**REVISED
DAVIS-BESSE NUCLEAR POWER STATION
EMERGENCY PLAN**

Davis-Besse Nuclear Power Station

Revision 33, Effective 12/06/18

Summary of Plan Changes

Emergency Response Organization
Page 1 of 10

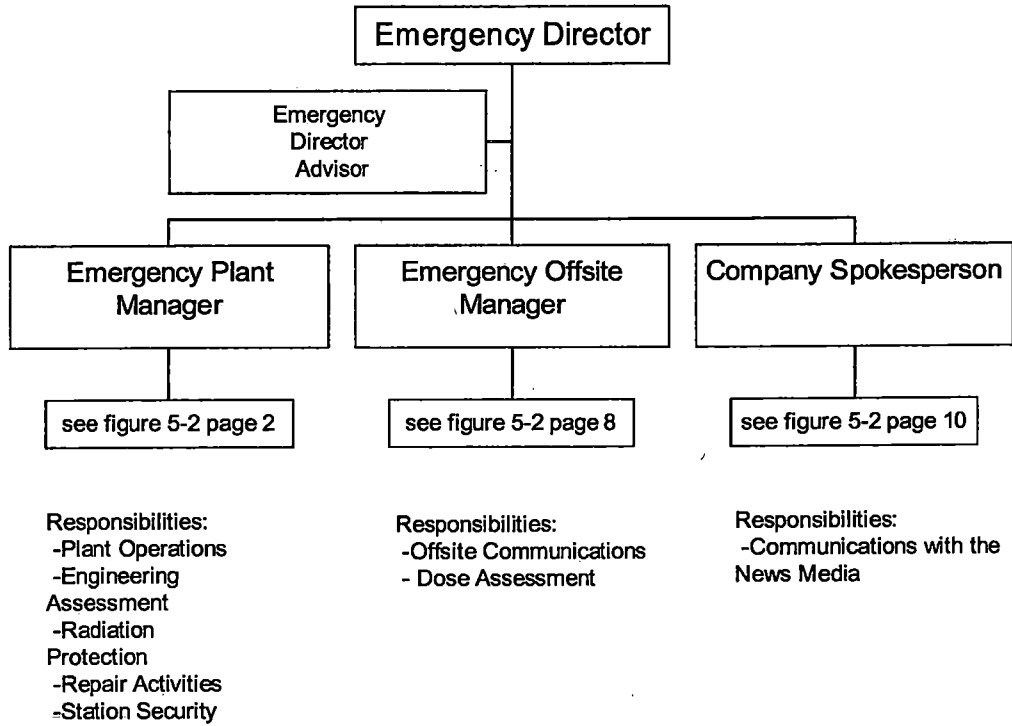
Figure 5-2, page 10	Removed "JIC Administrative Assistant" from organization chart.
Section 6.4.1.b	Changed the second and third sentence from "Personnel outside of the range of the Gai-Tronics system will be notified via bullhorn. Additionally, site personnel who are assigned pagers will automatically receive notification of the emergency condition" to "Personnel outside of the range of the Gai-Tronics system will be notified via bullhorn, ERO mobile device, or site public address system".
Section 7.1.2	Changed "The OSC is on the fourth floor of the Personnel Shop Facility (PSF). The area designated for the OSC consists of a conference room and an adjacent storage room. The OSC is the assembly and dispatch point for damage control and repair teams" to "The OSC is located on the third floor of the Containment Access Facility. The OSC is the assembly and dispatch point for damage control and repair teams".

**The following changes are being made to the DBNPS Emergency Plan:
Figure 5-2 - JIC Administrative Assistant to be removed.**

Emergency Response Organization
Page 6 of 10

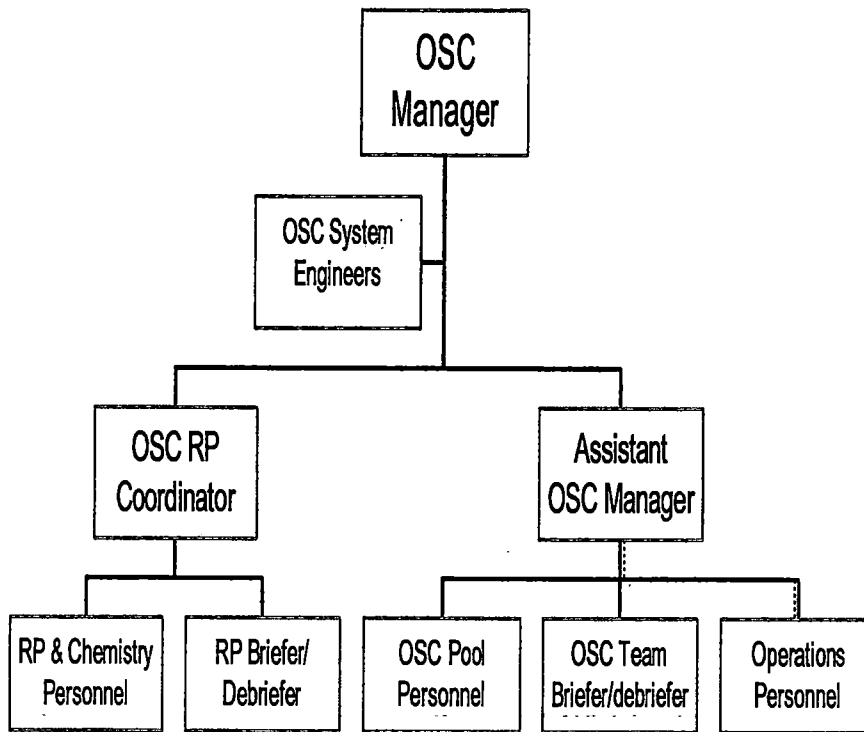
Figure 5-2, page 6 – OSC Material Manager to be removed.

Figure 5-2, page 6 - “Warehouse Pool Personnel” to be removed from organization chart and added to Figure 5-2, page 8 under “Resource Coordinator”.

Emergency Response Organization
Page 8 of 10

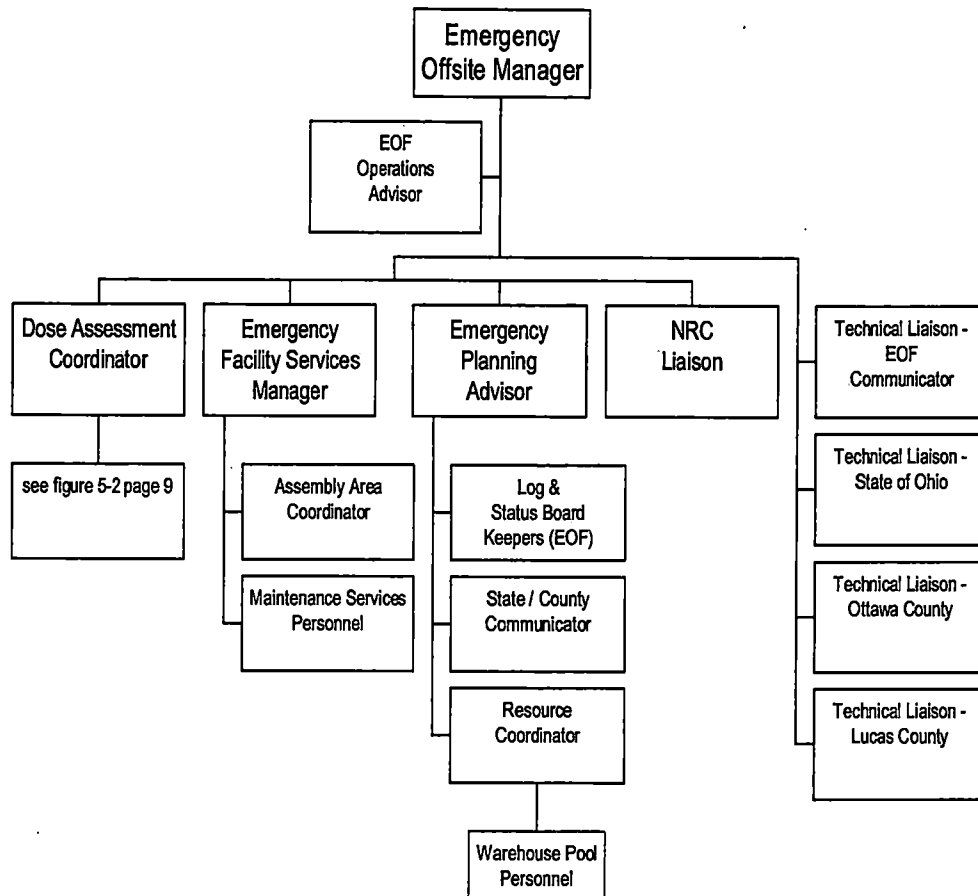
Figure 5-2, page 8 - Title “Policy Management Loop Communicator” to change to “Resource Coordinator”.

FIGURE 9-1**RECOVERY ORGANIZATION FRAMEWORK**

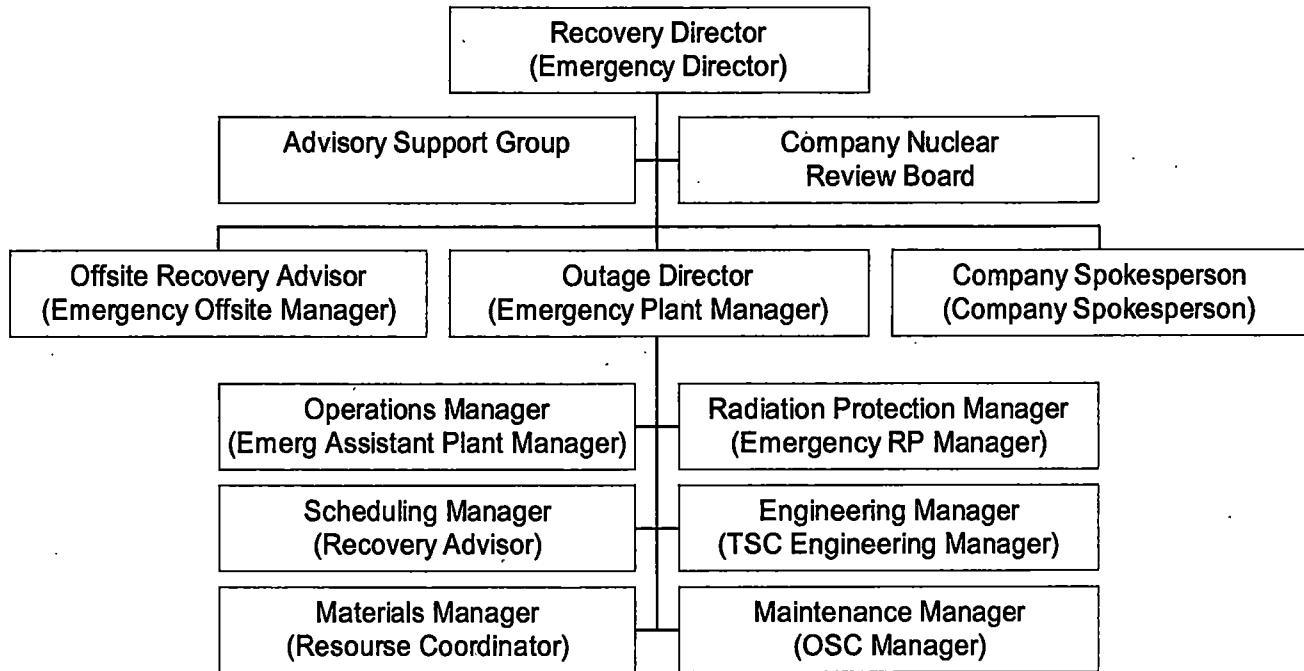
Figure 9-1	Changed "Materials Manager (OSC Materials Manager)" to "Materials Manager (Resource Coordinator)"
Appendix A Procedure and Related Document Index and Cross- Reference	Removed reference to RA-EP-00200, Emergency Plan Drill and Exercise Program
List of Appendices, Section 5.8.1, and Appendix C Contents	Removed reference to "Sample"
Appendix C Contents	Added "Ohio Department of Public Safety Emergency Management Agency"
Appendix C, Carroll Township	Added page 5 of Letter of Agreement.
Appendix C, page C-8, Lucas County	Added Lucas County EMA Letter of Agreement.
Appendix C, Promedica LOA	Updated Letter of Agreement with Promedica (previously Memorial Hospital)
Appendix C, Ohio EMA	Added Ohio Department of Public Safety Emergency Management Agency Letter of Agreement

Change 17 - Figure 9-1 - Changed "Materials Manager (OSC Materials Manager)" to "Materials Manager (Resource Coordinator)". (See Attachment 1, pages 19 & 20 for current and new revised wording).

Figure 9-1 - “Materials Manager (OSC Materials Manager)” – OSC Material Manager to be removed.
